Access Compliance Report

Public Rights-of-Way

Intersection ID: 29992	Main Street: REIGATE_RD	Cross Street: KEMPSFORD_DR	Location: W
ADA ID: 990F6541D7D7	Ramp Type: PerpDiag	Initial Pass/Fail: Fail	Overall Compliance: No
Codes/Mitigation Info/Possible Solution		Field Measurements/Component Compliance	
Severity Score: 22.5

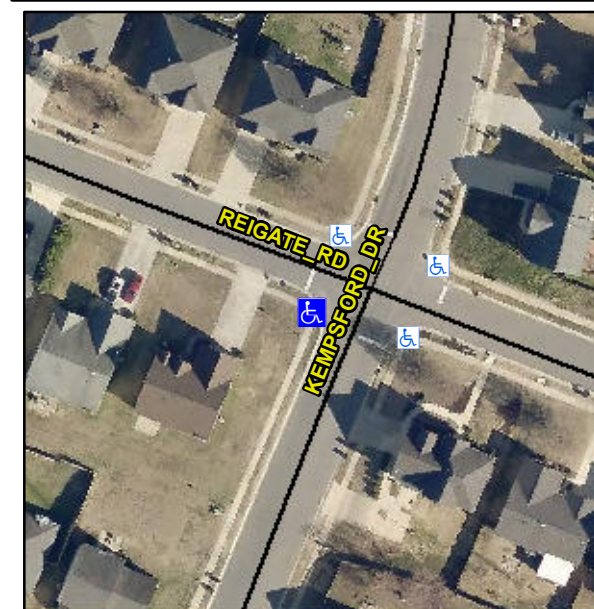
Not Found, R304.5.1, R304.2.2, R304.5.3

Compliance	Description	Data	Compliance	Description	Data
N/A	Ramp Length (in)	50.0	No	Ramp Slope (%)	10.5
No	Ramp Width (in)	43.0	No	Ramp XSlope (%)	3.7
N/A	Flare Type LT	N/A	N/A	Flare Type RT	N/A
N/A	Flare Slope LT (%)	N/A	N/A	Flare Slope RT (%)	N/A
N/A	Flare Traversable LT?	N/A	N/A	Flare Traversable RT?	N/A
N/A	Landing Length (in)	N/A	N/A	DWS Provided?	N/A
N/A	Landing Width (in)	N/A	N/A	DWS Contrast?	N/A
N/A	Landing Slope (%)	N/A	N/A	DWS Length (in)	N/A
N/A	Landing X Slope (%)	N/A	N/A	DWS Full Width?	N/A
N/A	Landing Curb? (Y/N)	N/A	N/A	DWS Offset (in)	N/A
N/A	Shared Landing?	N/A			
N/A	Gutter Ponding?	N/A	N/A	Gutter Slope (%)	N/A
N/A	Gutter Lip Ht (in)	N/A	N/A	Gutter X Slope (%)	N/A
N/A	Painted X Walk1?	No	N/A	Painted X Walk2?	No
	X Walk 1 Direction	To SE		X Walk 2 Direction	To NE
N/A	X Walk 1 Width (in)	N/A	N/A	X Walk 2 Width (in)	N/A
	X Walk 1 Slope (%)	2.8		X Walk 2 Slope (%)	1.9
	X Walk 1 X Slope (%)	2.0		X Walk 2 X Slope (%)	3.3

Remove & Replace Curb Ramp With Two New Directional Ramps or Equivalent.
